REMARKS

3. Proposed amendments to the drawings:

Fig. 6

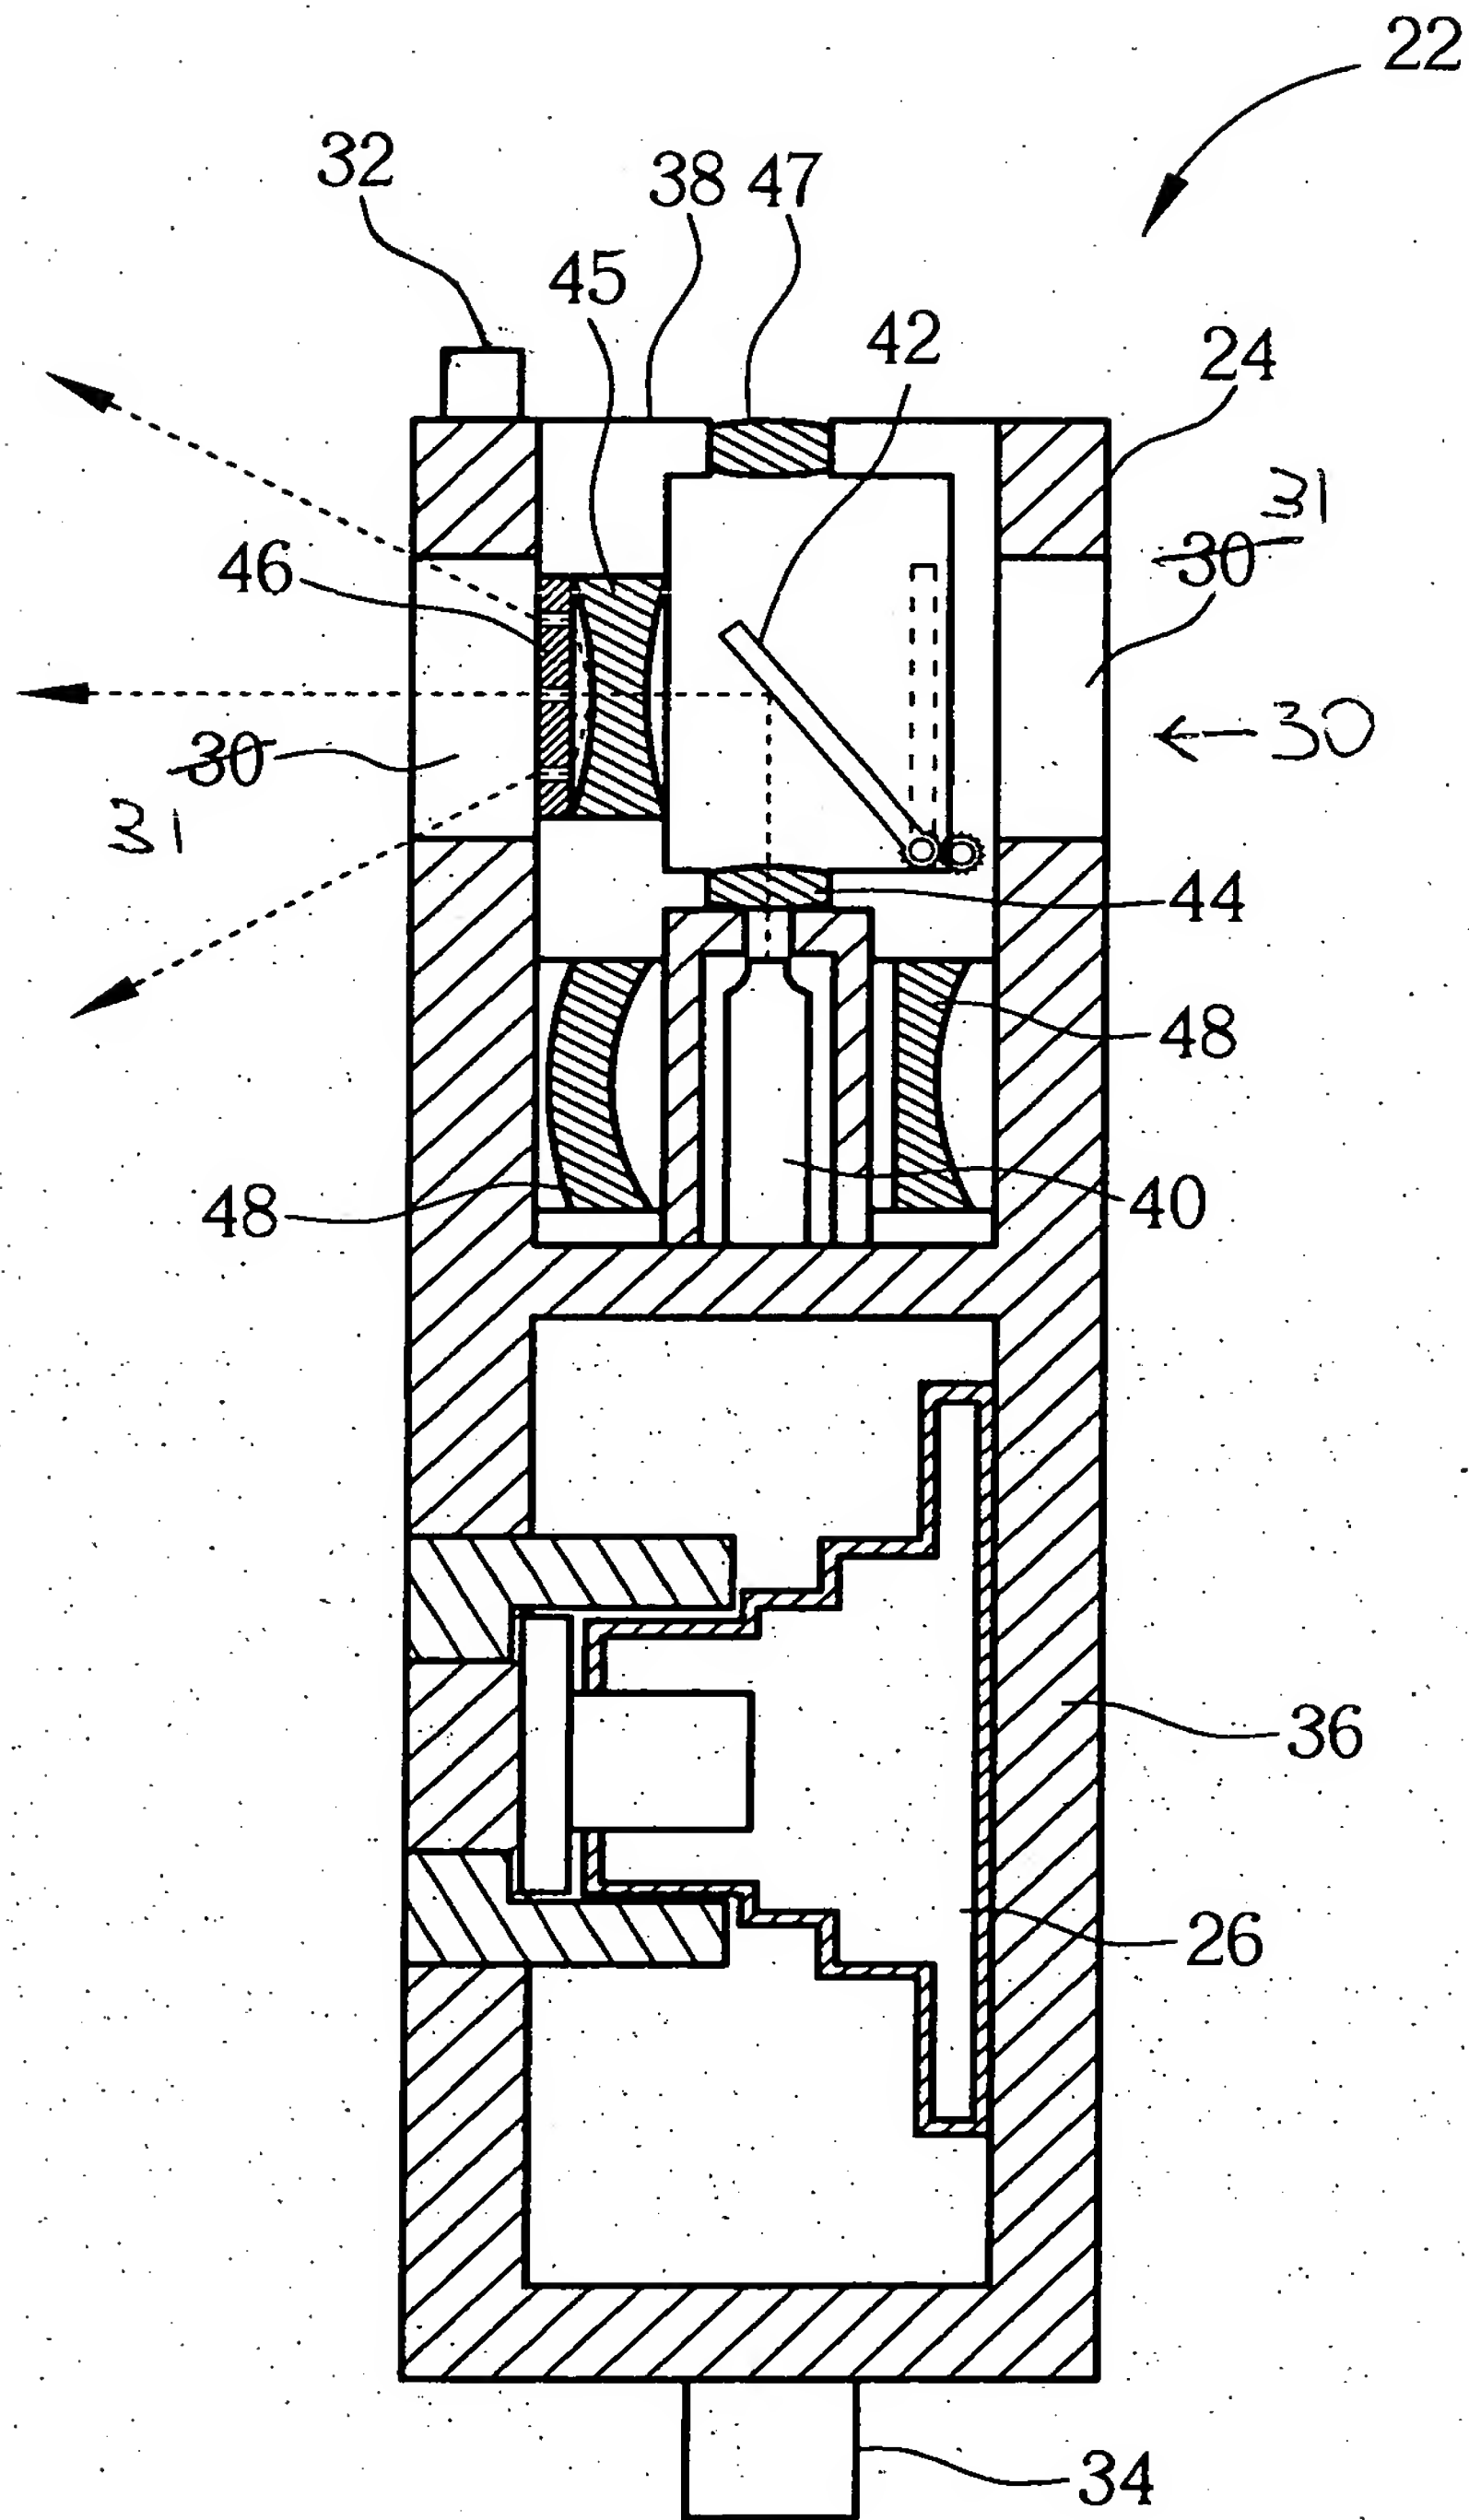
20 In paragraphs [0024], [0027], [0029], and [0032] "two optical viewfinders 30" is corrected to "optical viewfinder 30". For further clarification, these paragraphs are further amended to recite that the single optical viewfinder 30 comprises two ports 31, which are the illustrated holes in Figs.6, 10, and 12. The applicant believes that all instances of this error are corrected.

10 Figs. 6, 10, and 12 are amended to correctly illustrate the reference numeral 30 for the optical viewfinder and the numeral 31 for the two ports for consistency with the amended specification. Replacement sheets and annotated marked-up drawings are provided for these figures.
